## the parsonage

4132 brooklyn avenue ne  
seattle, wa 98105

DRB Recommendation Meeting  
DPD project #3018666

31 august 2015

historic photo of church and parsonage (c. 1907) landmarked together

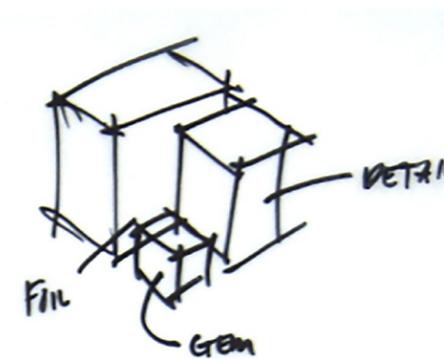
9. Design Review, Design Concept & Architectural Composition (DC2-A, DC2-B, DC2-E, DC3-A). Please demonstrate the intended overall concept between the massing and architectural composition of the existing structure and the proposed development.

The overall design concept for the project intends to celebrate the Historic Structure as the gem of the project. The addition is broken up into two additional parts "background building" and "foreground building" to create a scale that is more compatible with its context, and to minimize the scale contrast between the Parsonage and the New Construction.

The "foreground building" is more articulated and detailed given its presence at the street side. The "background" building remains simply articulated, lighter, with subtle references to the rest of the project.

On an urban scale, the project intends to recapture the the association between the Landmarks Structures - the Church and the Parsonage - which were landmarked together, but are unusually on two separate property lots. The project therefore considers a composition of three parts: The Church + the Parsonage + the New Addition.

perspective view of main entry (through Historic Structure) and of courtyard

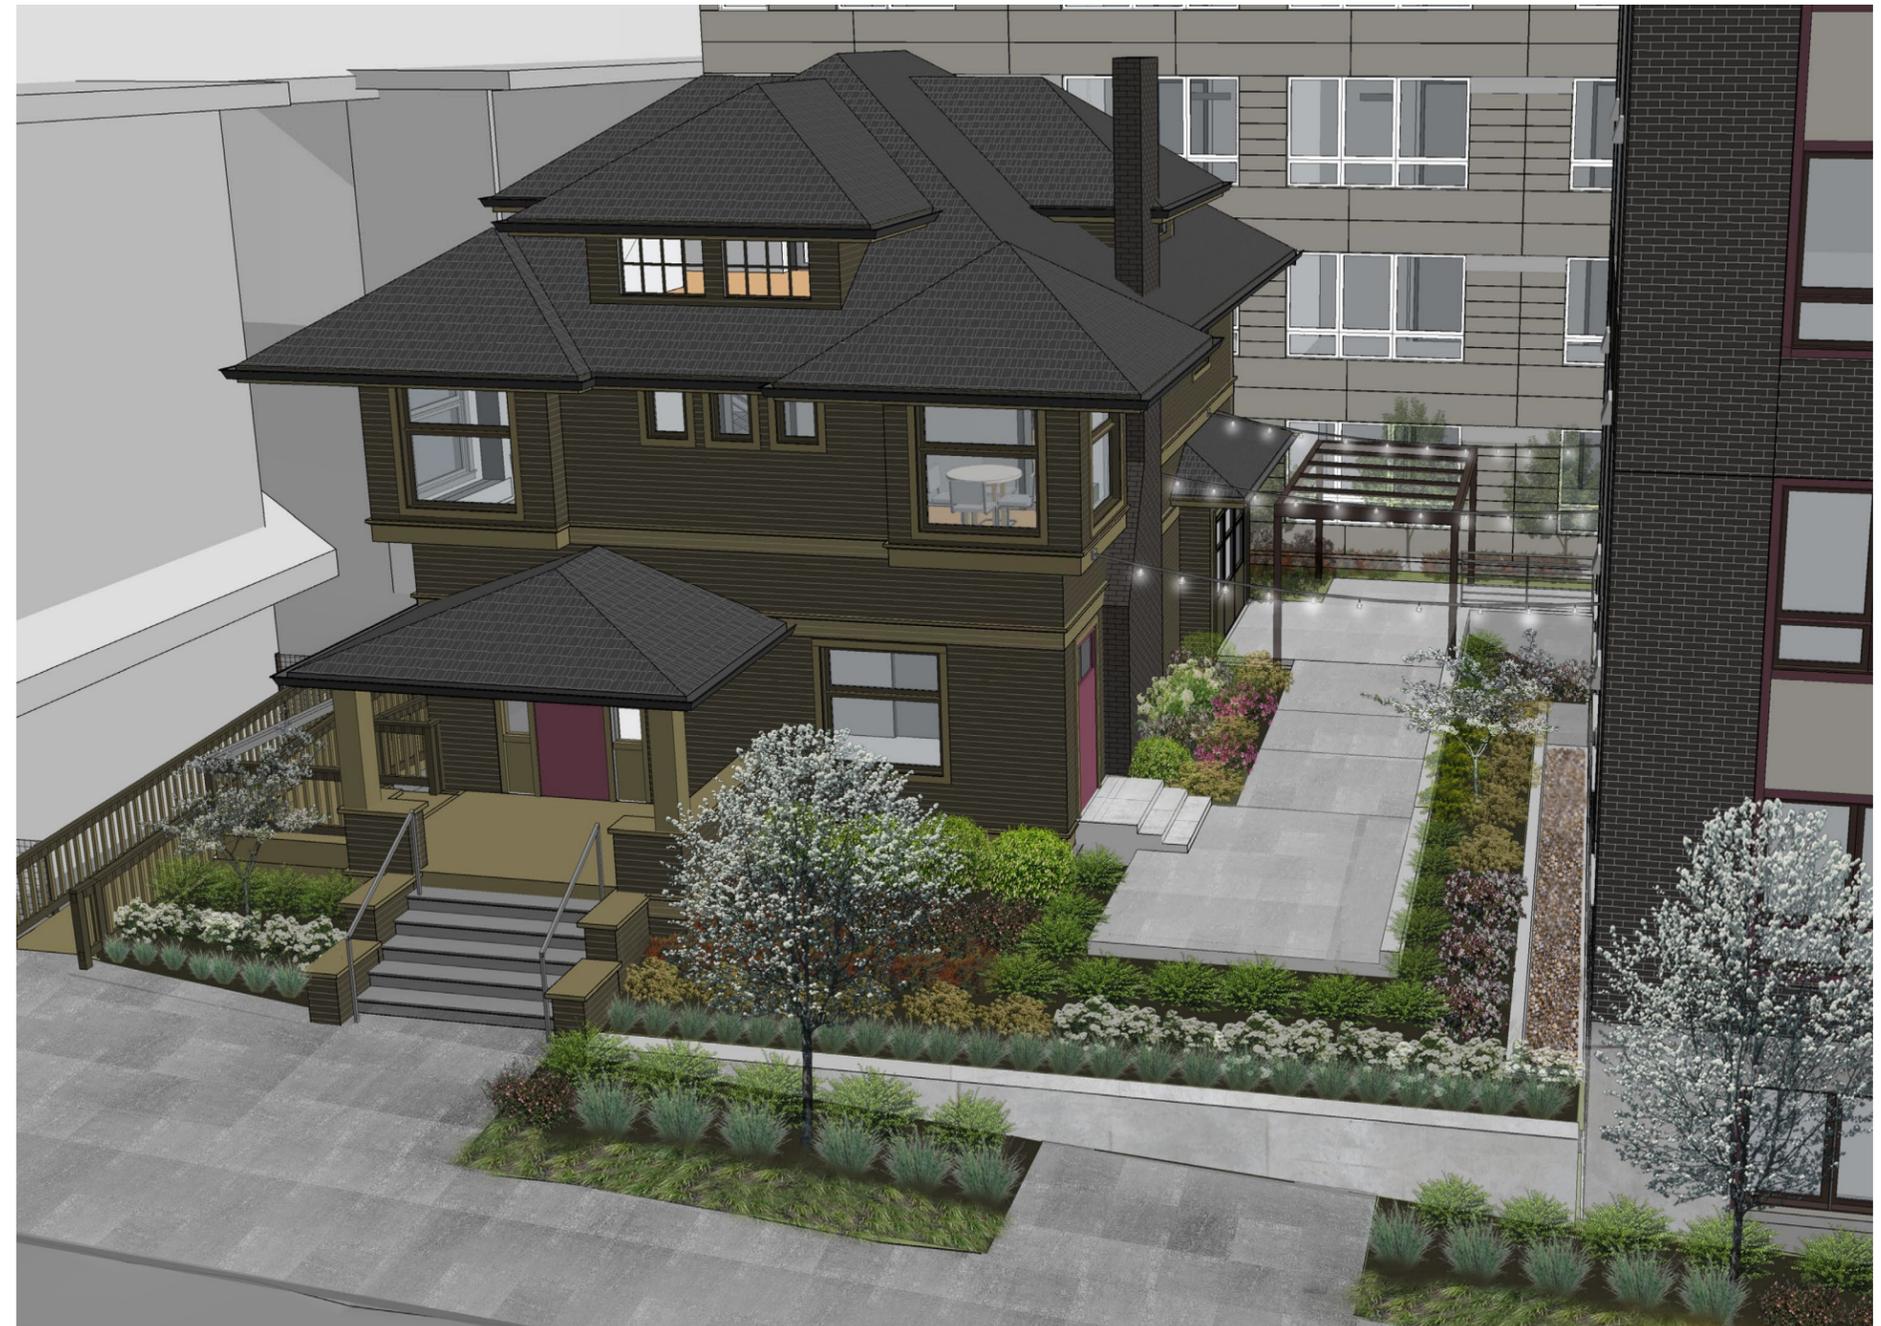
1a) Massing and Courtyard Design, Entry (CS2-B2, PL-B, PL3-A, PL1-I, PL3-I). The courtyard should be developed as part of the entry sequence into the Parsonage and the courtyard should function as an alternative entry point for residents and visitors.

The applicant's property management firm, Blanton Turner, manages over 2,000 units of student housing in the U-District, as well as many other college campuses. The residential life experience is one that is critical to the success of students, particularly those between the ages of 18-22. Because this housing product is intended primarily for undergraduate students, the importance of having students connect with the property management staff on a daily basis is critical, as is security.

For this reason, the main entry point for both residents and visitors needs to be through the Parsonage building - the courtyard no longer has an entry point function for the residents and visitors. In addition to serving as the main entry, the Parsonage will serve as the main activity location of all activities and social gatherings. This also allows the residential portions of the building to remain quieter and more private.

Having a single main entry point also enhances wayfinding and legibility (PL2-D, PL3-A, DC1-A). However, the courtyard remains visible from the street, providing visual ground-level open space to address the the severe lack of open space in the University District, a important public objective for the neighborhood (PL1).

plan at EDG, showing ramp and tiered courtyard, which have been eliminated.

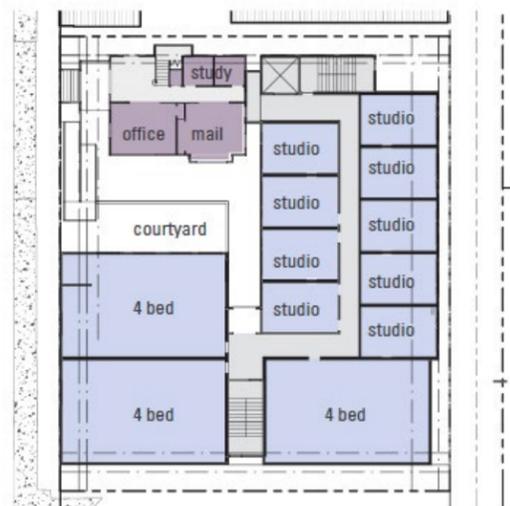
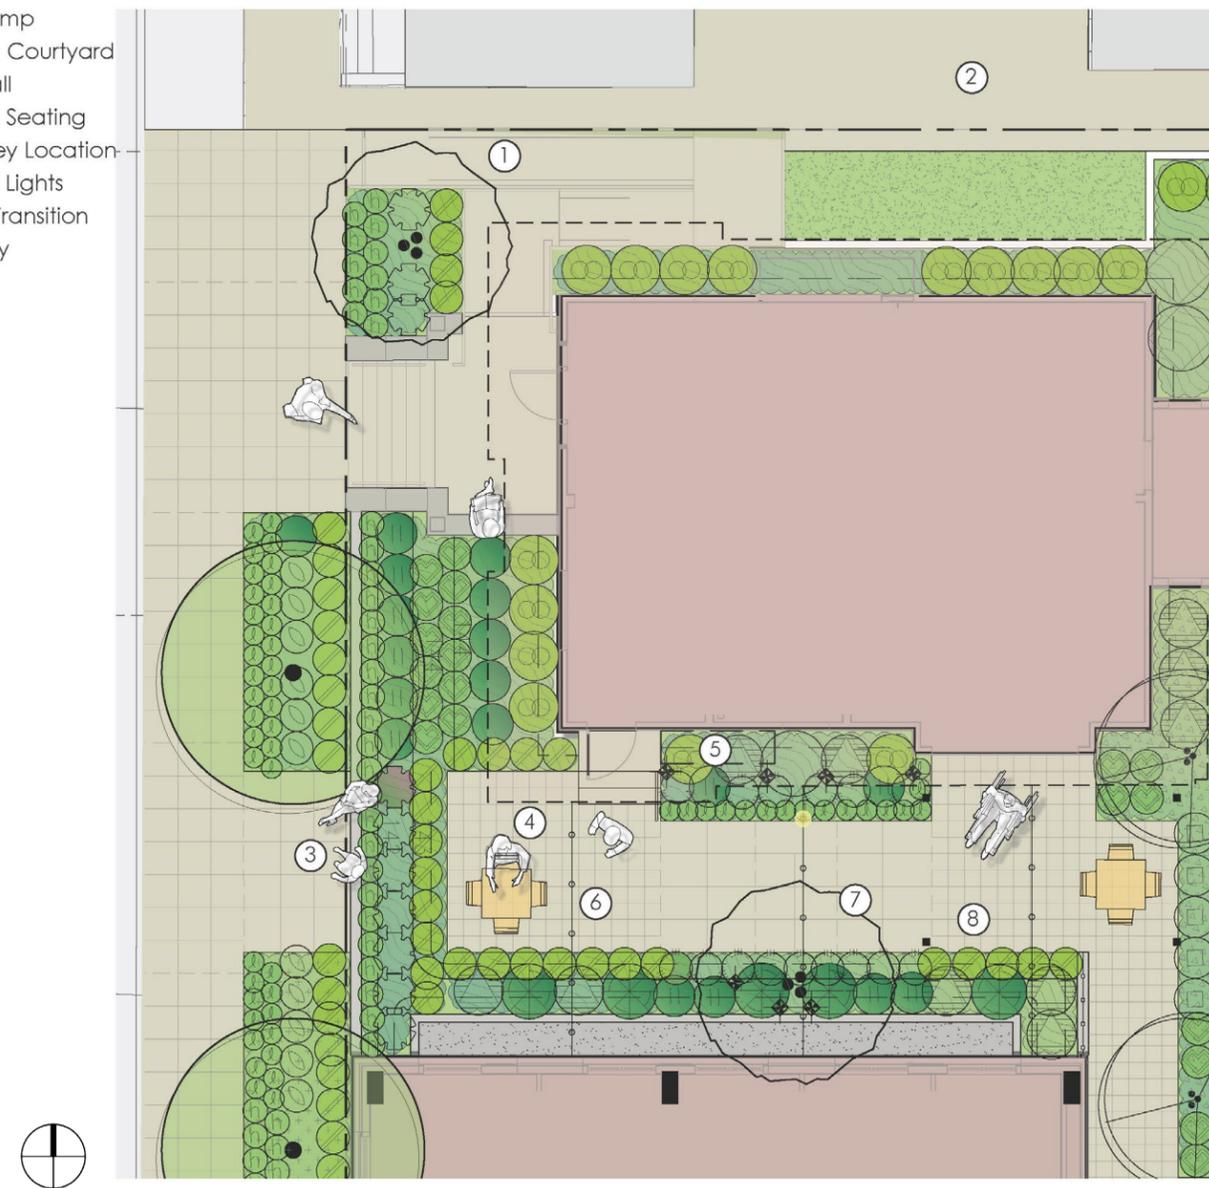
1c) Massing and Courtyard Design, Design Concept (PL1-I, PL3-I). The courtyard should be developed as one large courtyard space, or read as one large space, rather than being divided into multiple smaller spaces for private use by ground level residents

The ramp was moved to the north side of the Historic Structure in response to the EDG guidance to develop the courtyard design into one large courtyard space, instead of two terraces as shown at EDG. It is also in response to the Landmarks ARC comments to retain the character of the southwest facade of the Historic Structure by avoiding further additions and alterations.

Although the courtyard is skinnier, this design provides better light access to the Church's stained glass window, and enhances wayfinding and legibility since entry paths through the courtyard have been eliminated.

existing condition

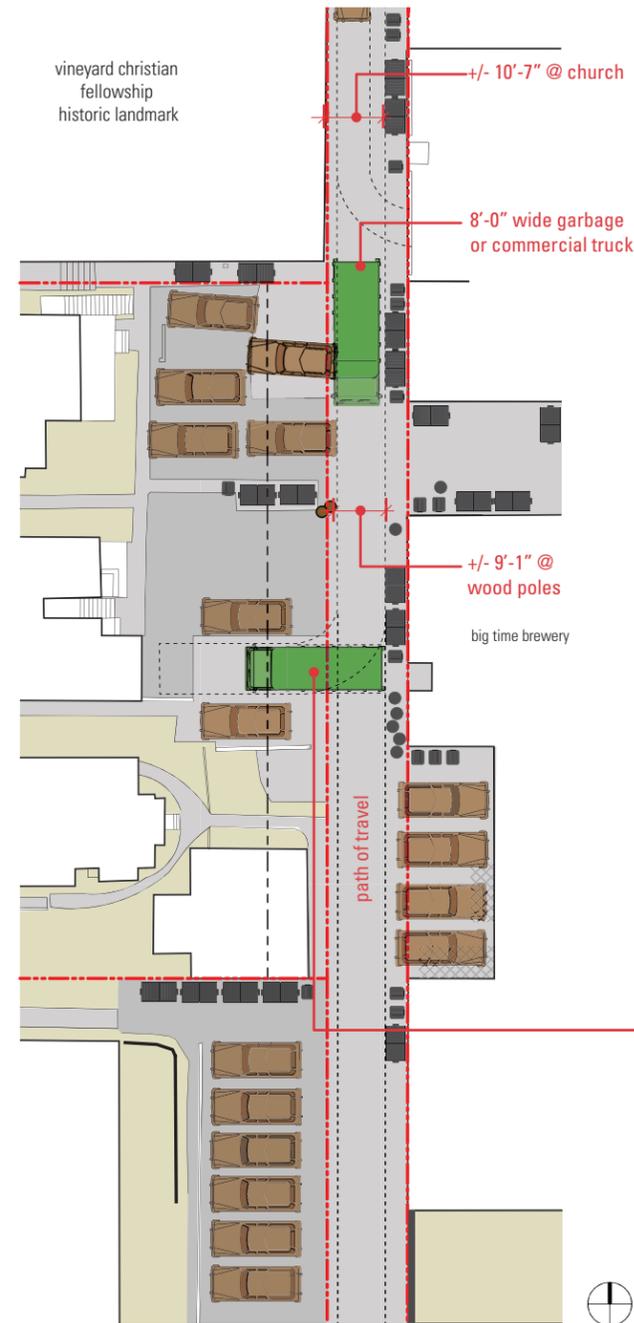
2a) Alley Design and Rear Setback Departure, Traffic Analysis, ( CS2-D, DC1-C). The Board requested an analysis showing how existing and proposed solid waste and recycling, truck loading and unloading for commercial uses, and vehicular traffic along the alley will function with the new proposed building and reduced setback. The Board indicated potential support for a reduced rear setback if the proposed design is sensitive to the tight programming in the alley.

Currently, the narrowest portion of the alley is governed by existing wood utility poles (approximately 9'-1"). The width of the alley is further reduced by neighbors across the alley placing their solid waste and recycling containers in the alley R.O.W.

A standard 8'-0" wide garbage truck can currently use the alley for garbage and recycling pick-ups, though the alley is congested.

Commercial loading for some neighboring sites currently uses the subject property.

section through alley

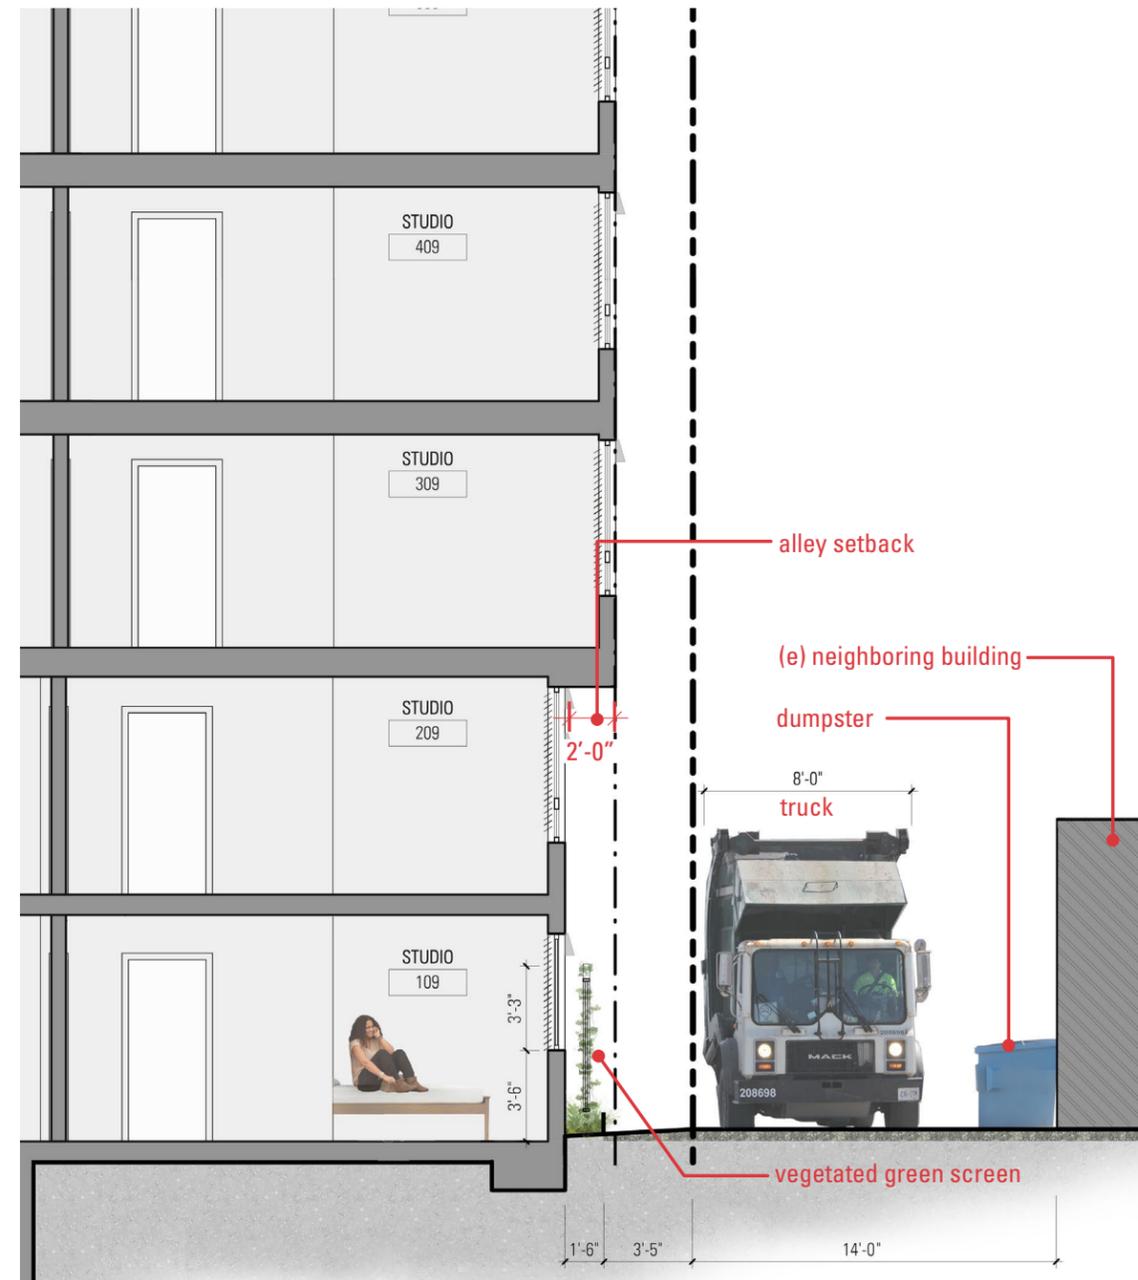
2b) Alley Design and Rear Setback Departure, Ground Level Units (CS-2D, PL3-B, DC1-C). The building and rear setback must be sensitive to the existing alley condition and provide a buffer between ground level residential units and the alley.

2c) Alley Design and Rear Setback Departure (CS2-D, DC1-C). The Board will review future rear setback departure requests once the additional analysis is provided. The Board indicated support for a reduced rear setback departure request. To relieve the tight programming on the alley the Board indicated support for additional massing at the upper level along the street, or alternatively, an increased ground level setback with upper level cantilever of the alley.

Vegetated green screens will be provided for ground level units for privacy. The units have also be set back 2 ft.

The building has been setback at the ground level by 2 ft, with an upper level cantilever. Wood utility poles that were the pinch point in the alley, have been removed to relieve congestion in the alley.

## 2 | ALLEY DESIGN | move-in and move-out

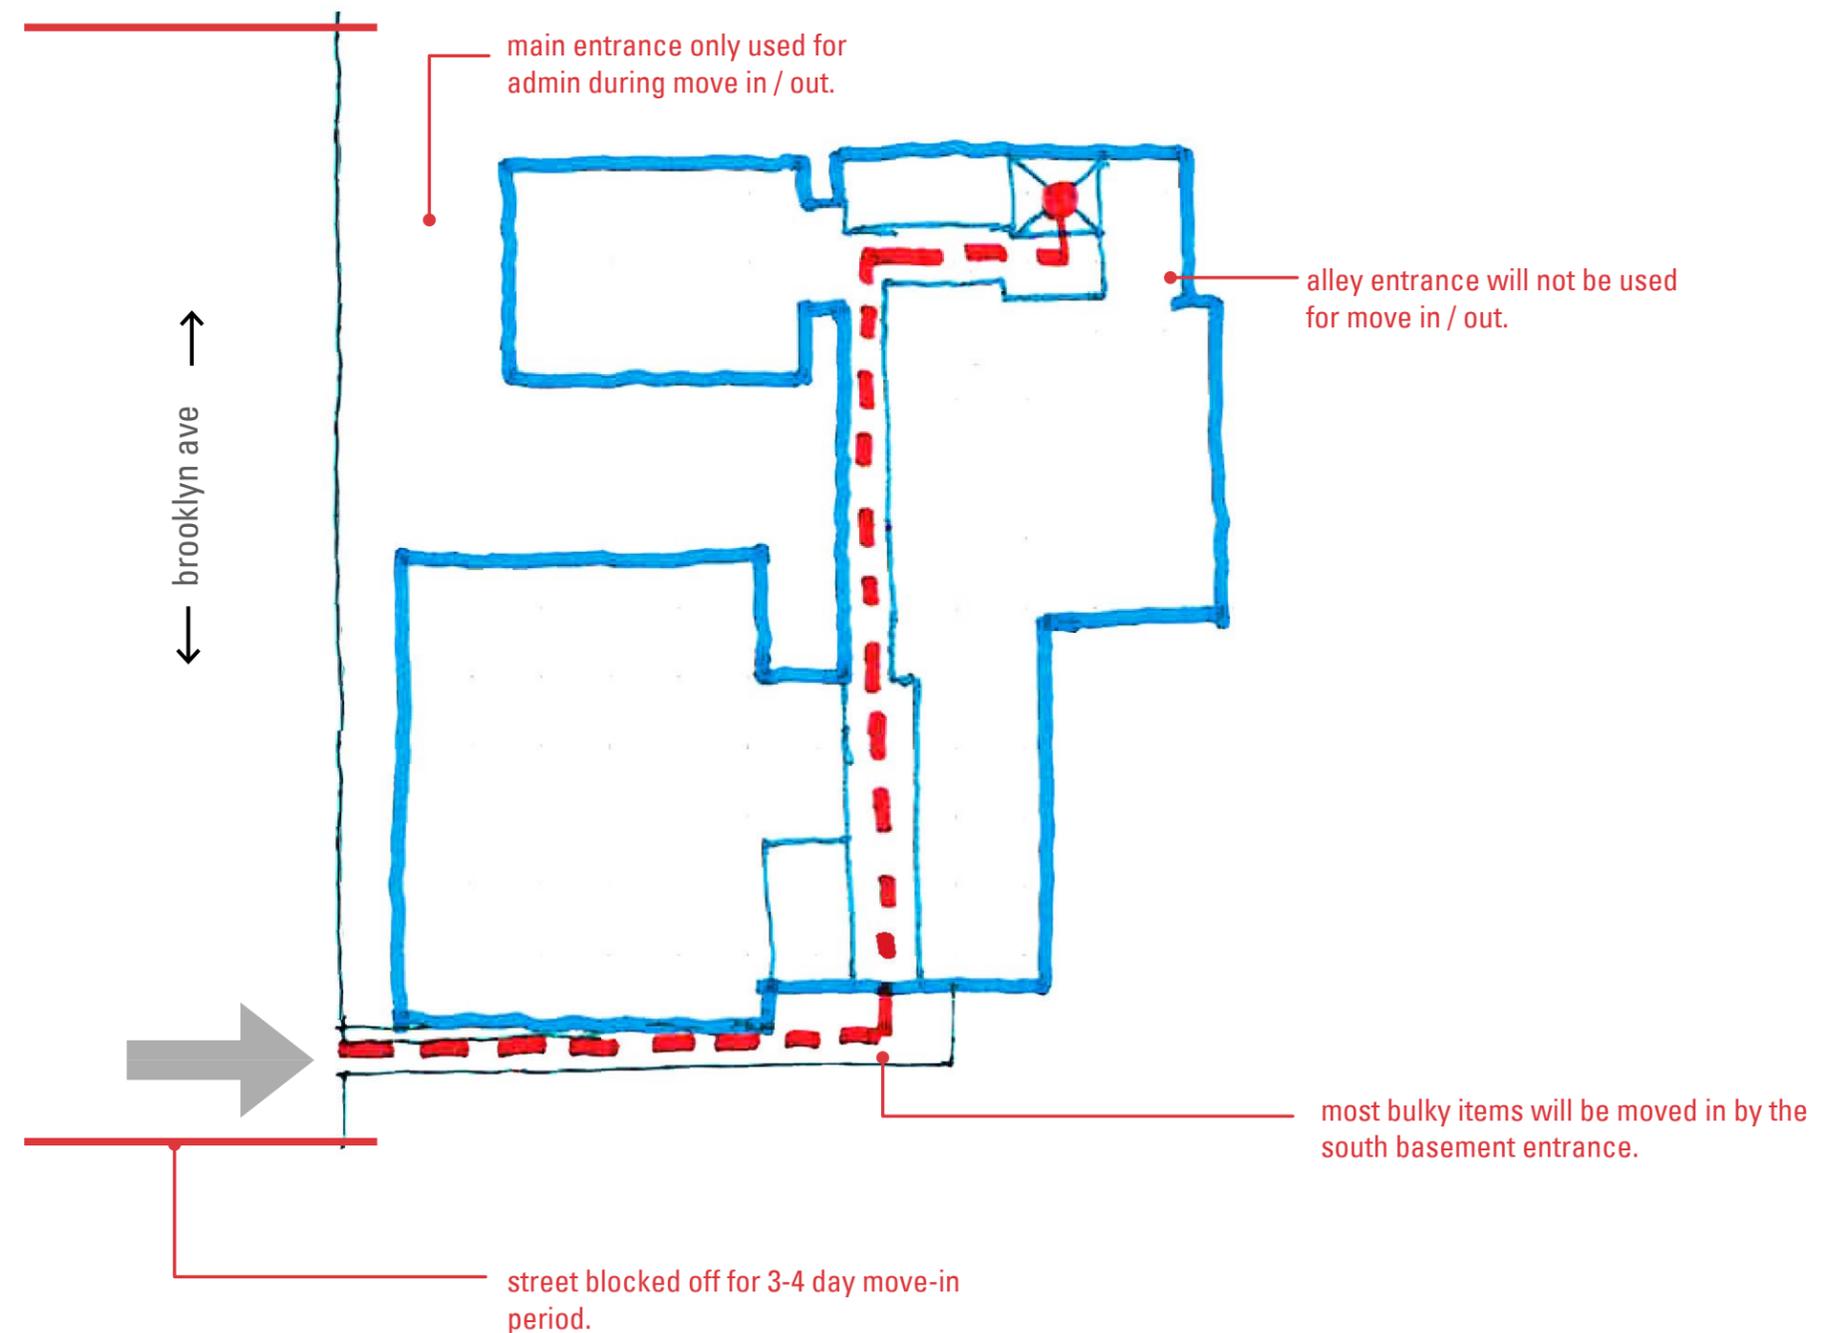
2e) Alley Design and Rear Setback Departure, Move-In/Move-Out. At the Recommendation Meeting, the applicant should demonstrate how tenants will stage moving in and out of the structure.

Because of the known congestion in the alley, the proposed design does **not** propose move-in/move-out to occur at the alley.

UW and the property manager for this project, Blanton Turner (BT) coordinate to block off the streets for the 3-4 day period that everyone moves in. BT has ample on-site staff to facilitate the move-ins, just like they do in the dorms on campus.
